**Docket:** NRC-2024-0078

US SFR Owner, LLC; Construction Permit Application Comment (2)

US SFR Owner, LLC.; Kemmerer Power Station Unit 1; Notice of Intent To Conduct Scoping Process and Prepare Environmental Impact Statement

# Pool Type Sodium-Cooled Nuclear Reactor - Concerns

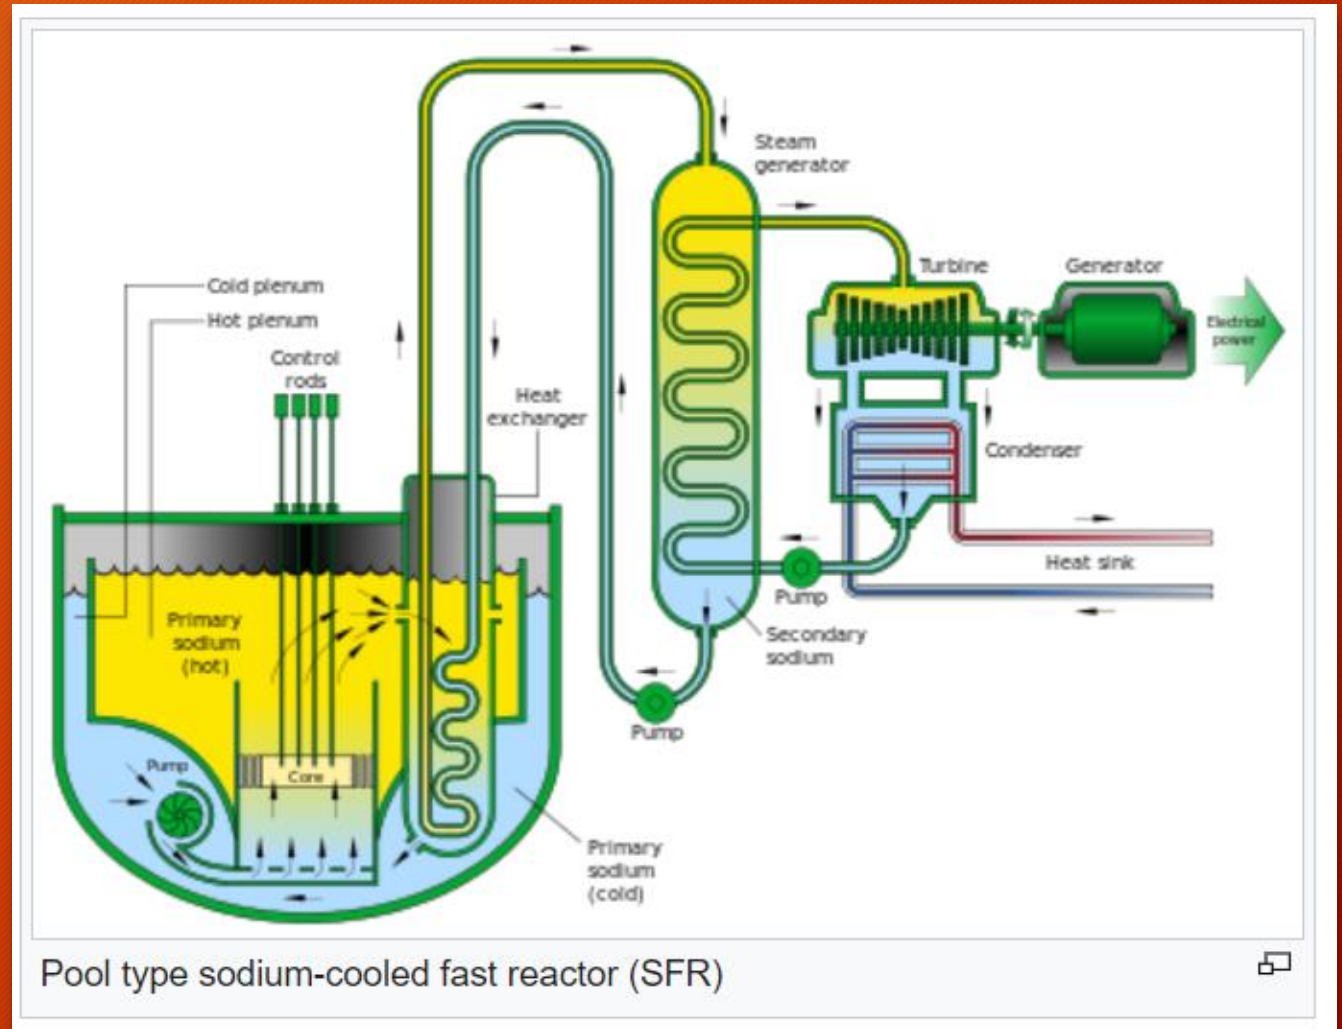
- What about upsets in the external heat exchanger loop?
  - Sodium can still freeze in the external loop including heat exchanger and piping? How would that be remelted after upset?

- Thermal shock or loss of steam side pressure could cause severe tube vibration and rupture, leading to water coming in contact with sodium.
  - If water gets in contact with sodium, BOOM!!!
